UNITED STATES PATENT AND TRADEMARK OFFICE

APPLICATION NO.	FILING DATE	FIRST NAMED INVENTOR	ATTORNEY DOCKET NO.	CONFIRMATION NO.
10/737,355	12/16/2003	Brent R. Jones	D/A3075	6010

Office Action Summary	Application No.	Applicant(s)	
	10/737,355	JONES, BRENT R.	
	Examiner	Art Unit	
	Leonard S. Liang	2853

DETAILED ACTION***Drawings***

FIG. 4

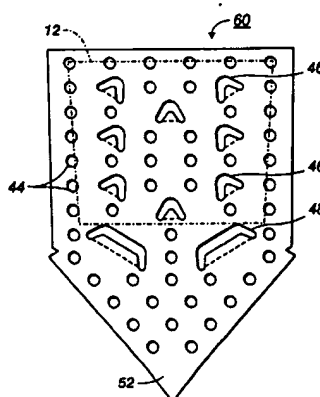
- {claim 1} A drip plate for use in a phase change ink jet printer using solid ink, comprising: an upper portion; and a lower pointed portion, wherein the lower portion is not coplanar with the upper portion (figure 4; column 6, lines 65-67)

- {claim 12} at least one anchor tab extending from the second side of the drip plate located near the center of the plate (figure 4, reference 46)
- {claim 13} wherein the anchor tabs are arranged in pairs and wherein each pair is arranged substantially symmetrically about a vertical center line (figure 4, reference 46)

- {claim 14} a silver strainer located near a lower edge of the drip plate (figure 4, reference 48)
- {claim 15} An ink loader (figure 3)
- {claim 16} An ink loader for a phase change ink printer (figure 3), comprising: at least one channel having an entry end and an exit end (figure 3, reference 25A-D); a melt assembly, which includes a drip plate including an upper portion

FIG. 3

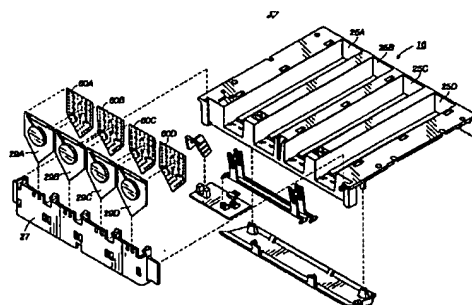
- {claim 2} wherein a heating element is bonded to a first side of the upper portion (figure 3, reference 29A-D)

- {claim 3} wherein the heating element is a closed loop heater (figure 3, reference 29A-D)
- {claim 6} wherein the drip plate is made from metal (column 7, lines 16-17)

having substantially flat upper first and second sides, and a lower portion having substantially flat lower first and second sides, wherein the lower portion is not coplanar with the upper portion (figure 3, reference 60A-D; column 6, lines 65-67); a melt plate fastened to the upper second side of the drip plate; and a heating device thermally connected to one of the melt plate and the drip plate (figure 3, reference 29A-D)

- {claim 17} further comprising an adapter to position the assembly relative to the at least one channel (figure 3, reference 27)
- {claim 18} wherein at least one of the drip plate and the melt plate is made from nonferrous metal (column 7, lines 16-17)
- {claim 19} wherein at least one of the drip plate and the melt plate is made from aluminum (column 7, lines 16-17)
- {claim 23} wherein the heating element is a closed loop heater (figure 3, reference 29A-D)
- {claim 26} wherein the melt plate includes at least one anchor tab extending from the second side of the drip plate (figure 4, reference 46)
- {claim 27} wherein the melt plate includes a silver strainer located near a lower portion of the drip plate (figure 4, reference 48)
